ADCO ITP Documentation

LGF Pour 1a

Contents

LOWER GROUND FLOOR SLAB PLAN - GRID A - C

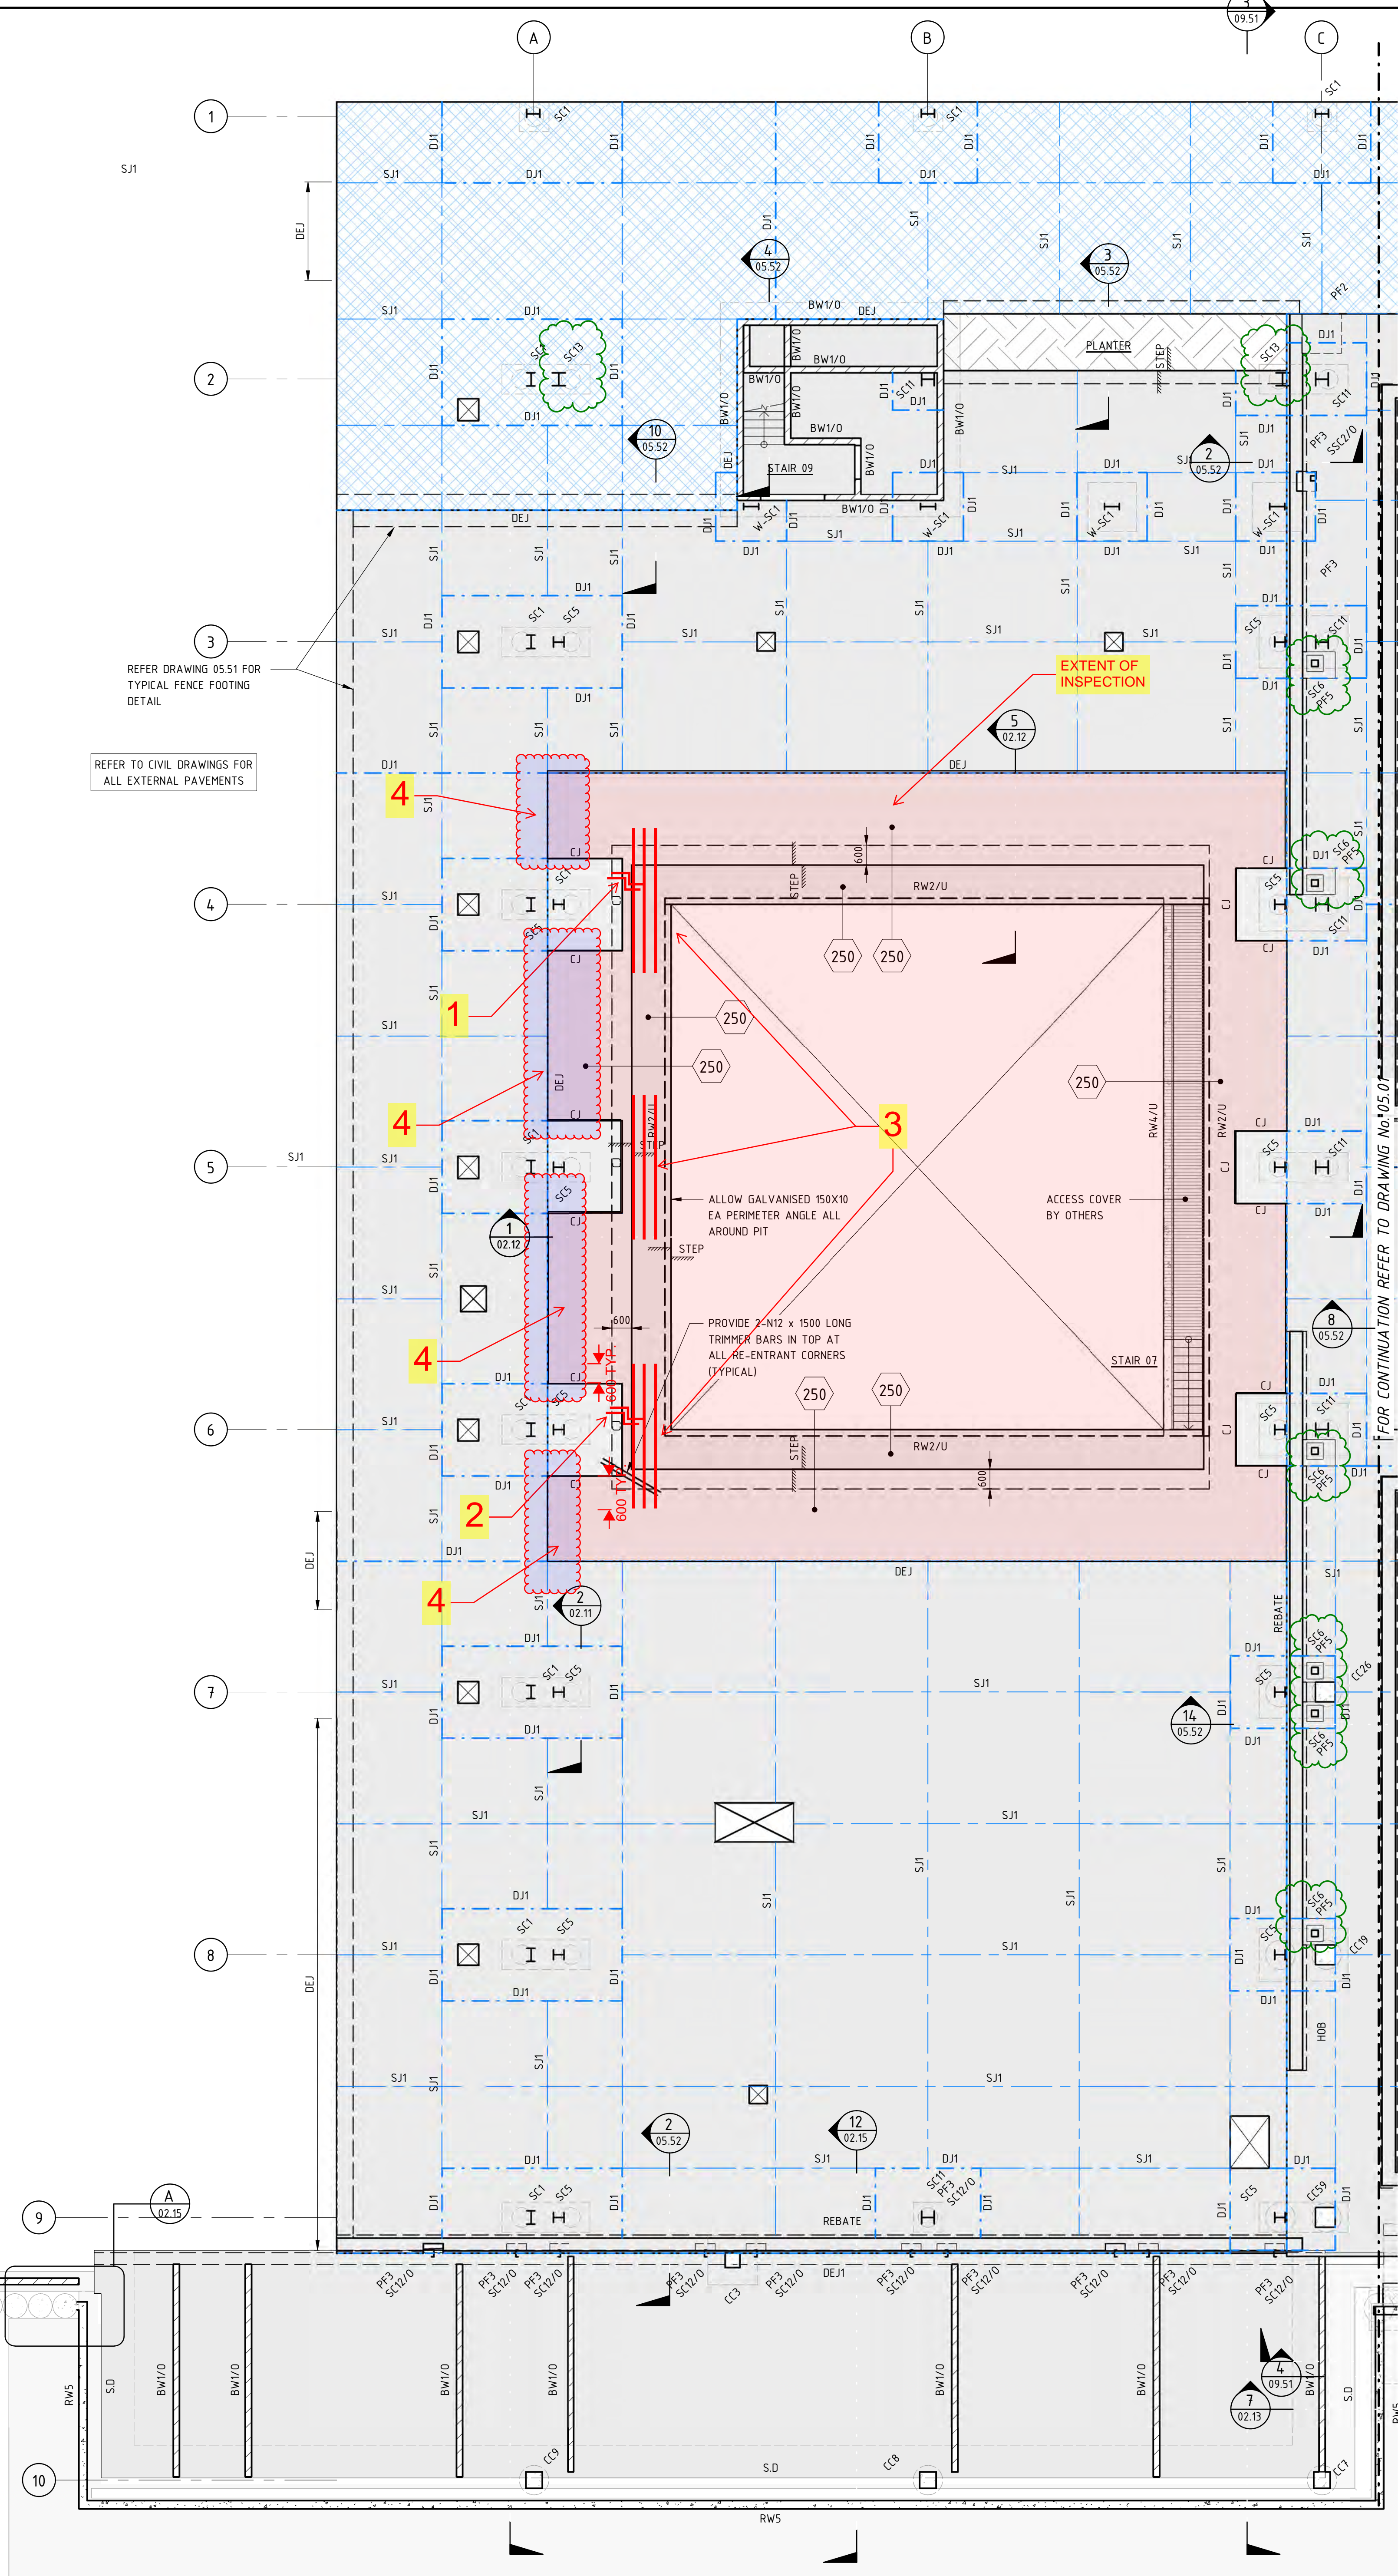
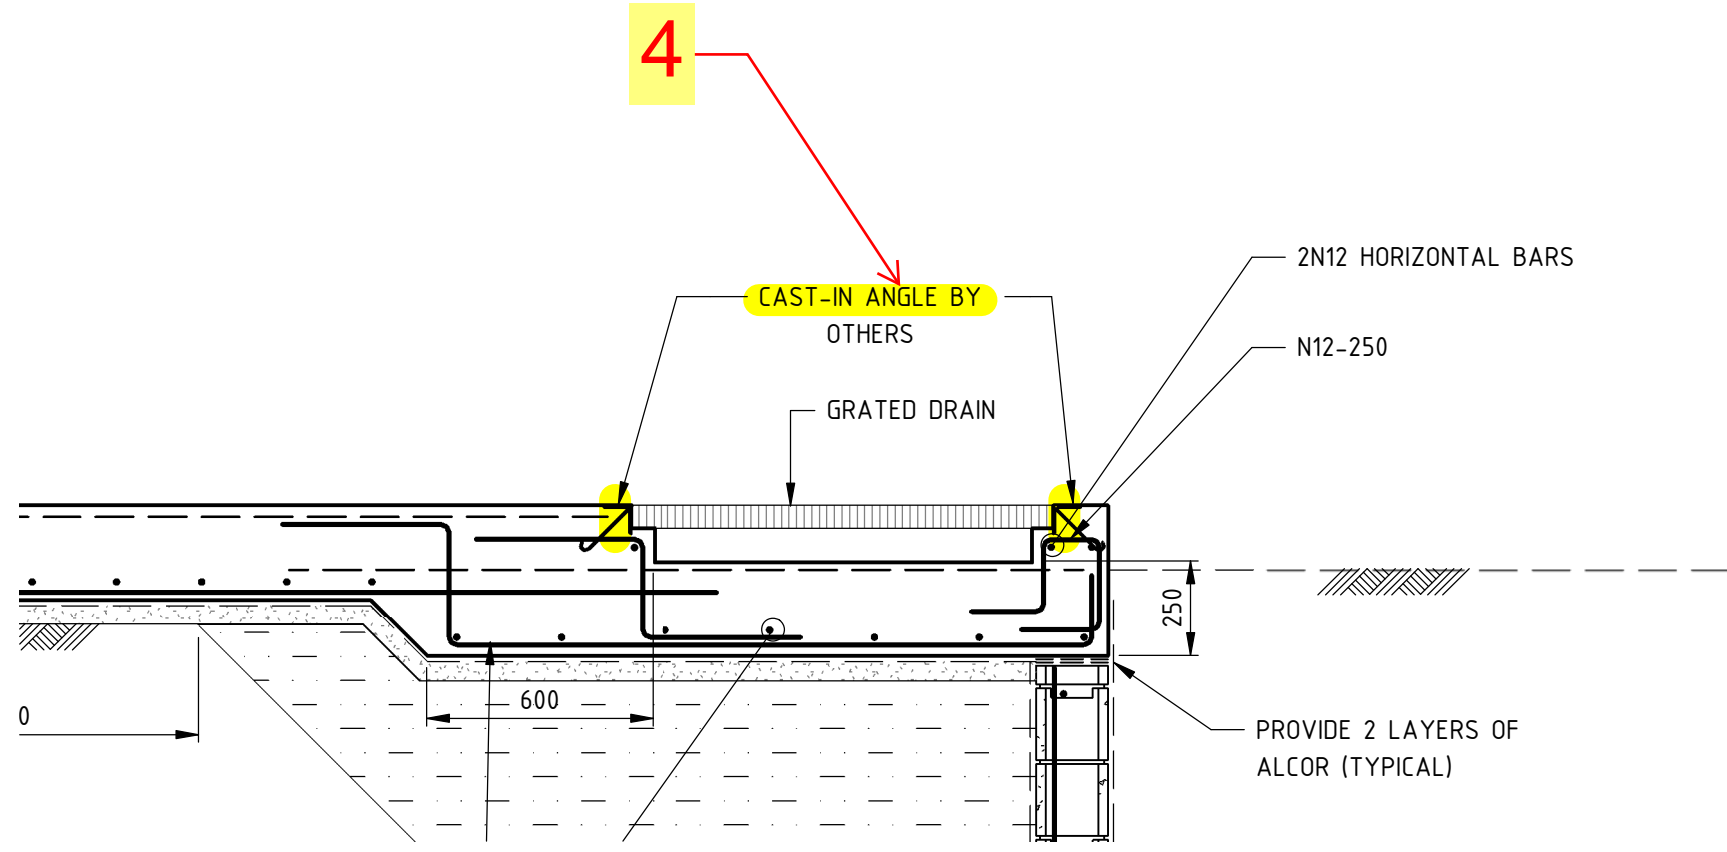
- 1) Install N16 Z-Bars bottom and N12 top Z-bars as per section 1 on drawings S02.12
- 2) Install N16 Z-Bars bottom and N12 top Z-bars as per section 1 on drawings S02.12
- 3) Install 3N12 bottom bars at three locations to trim the suspended slab since the back span is discontinuous due to the column block outs.
- 4) Finish installing reinforcement as various areas that were not completed yet
- 5) Finish installing the cast-in angles all around the grid.
